NORTHERN REGIONAL PLANNING PANEL

ADDENDUM COUNCIL ASSESSMENT REPORT

Panel Reference	PPSNTH-11
DA Number	DA2020-0138
LGA	Tamworth Regional Council
Proposed Development	Organic Recycling Facility
Street Address	284 Gidley Appleby Road, GIDLEY NSW 2340
Applicant/Owner	Tamworth Regional Council
Date of DA lodgement	24 September 2019
Number of Submissions	116 over two public exhibition periods.
Recommendation	Approval, subject to conditions
Regional Development Criteria (Schedule 7 of State Environmental Planning Policy (State and Regional Development) 2011)	CIV > \$5M - Council interest
List of all relevant s4.15(1)(a) matters	<ul style="list-style-type: none"> • <i>Environmental Planning and Assessment Act 1979</i> • <i>Environmental Planning and Assessment Regulation 2000</i> • <i>State Environmental Planning Policy (State and Regional Development) 2011</i> • <i>State Environmental Planning Policy (Infrastructure) 2007</i> • <i>State Environmental Planning Policy No 44 – Koala Habitat Protection</i> • <i>State Environmental Planning Policy No 33 – Hazardous and Offensive Industry</i> • <i>State Environmental Planning Policy No 55 – Remediation of Land</i> • <i>Tamworth Regional Loc

Figure 1: Plan showing existing and proposed stormwater drainage paths, and proposed water monitoring locations – *Supplementary Information – Leachate Management prepared by Pitt & Sherry, dated 26 June 2020.*

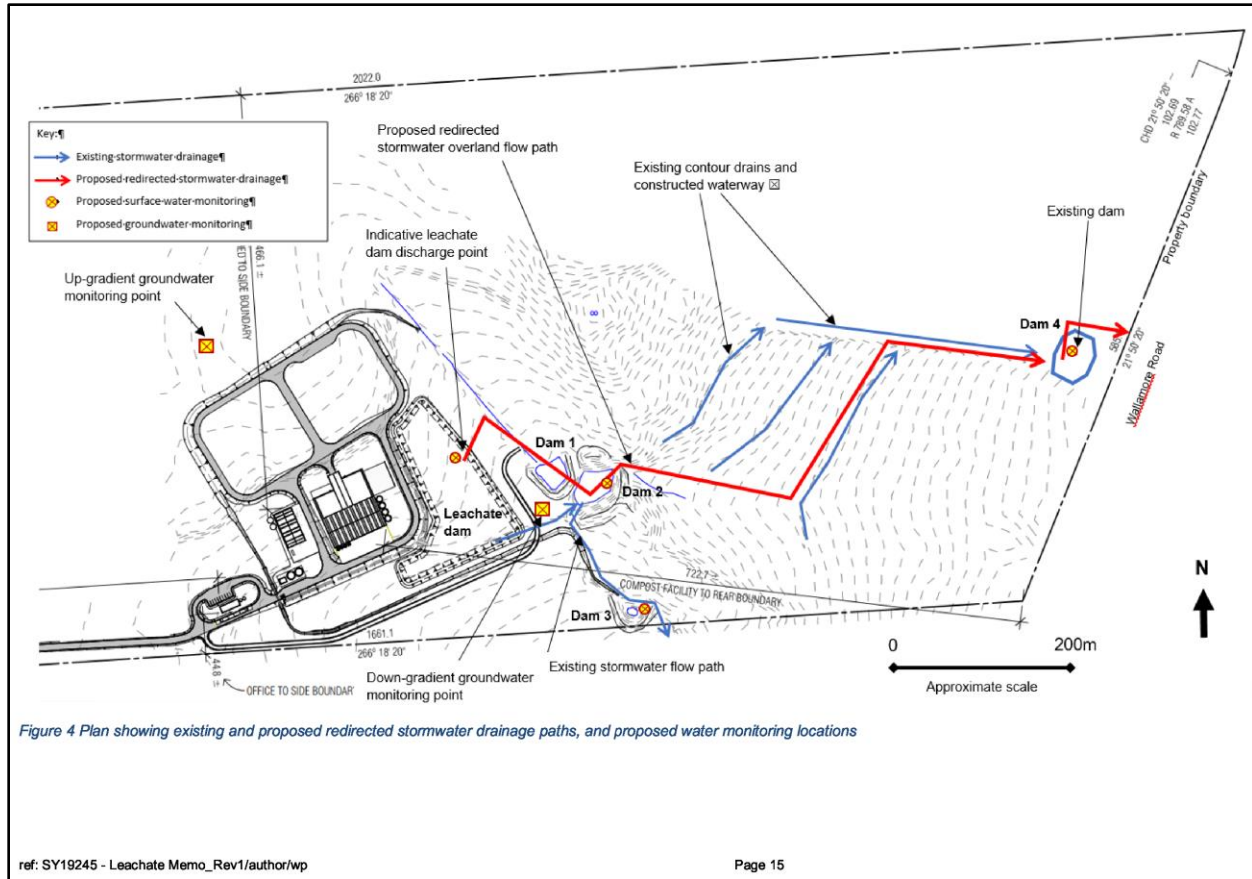
It is probable that during the times of greatest leachate generation (by volume), during large storm events, the leachate concentration will be weakest and heavily diluted. The leachate that is captured in the leachate dam is not expected to contain high or problematic concentrations of pathogenic organisms, given that the leachate source will be the pasteurised compost. Stormwater must travel a large distance over gently undulating terrain before reaching the Peel River. The intervening lands are low gradient, agricultural land and the soils and vegetation on these lands would have ample capacity to assimilate nutrients in stormwater from the site and the broader catchment area that drains to these lands. Leachate from the facility is not expected to contain any toxic or hazardous constituents in strengths that would be detrimental to adjoining lands or waterways.

The discharge pathway for any leachate overflows would be controlled so as to minimise potential impacts on neighboring land uses, particularly the nearest adjoining landowner to the south. A drainage diversion is proposed to divert stormwater from the facility (and any leachate overflow) to the east and along a maximum flow path within the subject property under the control of Council, before leaving the site. Currently stormwater runoff from the proposed location of the facility follows a flow path to the south, via a series of dams, before crossing the southern property boundary and discharging south to the adjoining farmland. The proposed diversion will extend the runoff flow path within the subject site to further dilute the leachate and minimise the potential risk of contamination. Please refer to figure 1 below in relation to the overland stormwater drainage flow path.

Leachate quality within the leachate dam will be monitored as part of a broader water quality monitoring program for the site as required for the Environmental Protection License (EPL) for the facility. Specific details on the monitoring program will be outlined prior to the issuing of the EPL and will be included as part of the Operational Environmental Management Plan. An indicative program would include, as a minimum:

- Detail on the monitoring locations, frequency and parameters to be tested, as agreed with EPA and in line with the issued EPL;
- Proposed surface water monitoring locations, which are expected to include four on-Site and four off-Site (downstream) points, including:
 - Leachate dam (near outlet)
 - Stormwater Dam 2 downstream of leachate dam (near outlet)
 - Stormwater Dam 3 near southern boundary
 - Stormwater Dam 4 near eastern site boundary (final discharge point of stormwater from Site)
 - Four off-site downstream locations on neighboring properties, selected based on identification of potential off-site flow paths and receiving water locations;
- Proposed groundwater monitoring locations, which are expected to include:

- Groundwater monitoring bore up-gradient of processing area, nominally to the north-west of the maturation pad
- Groundwater monitoring bore down-gradient of processing area, nominally to the east of the leachate dam;
- Analytes to include, as minimum: pH, EC, TSS, Oil and Grease, BOD, Total Phosphorus, Total Nitrogen, Ammonia, Metals (to be determined);
- Monitoring frequency to include:
 - Monthly leachate quality monitoring for the first year of operation
 - Quarterly for all monitoring points (potentially reducing to 6-monthly over time dependent on results)
 - Daily during any leachate overflow, monitoring at the leachate discharge point and downstream stormwater dams on the site.
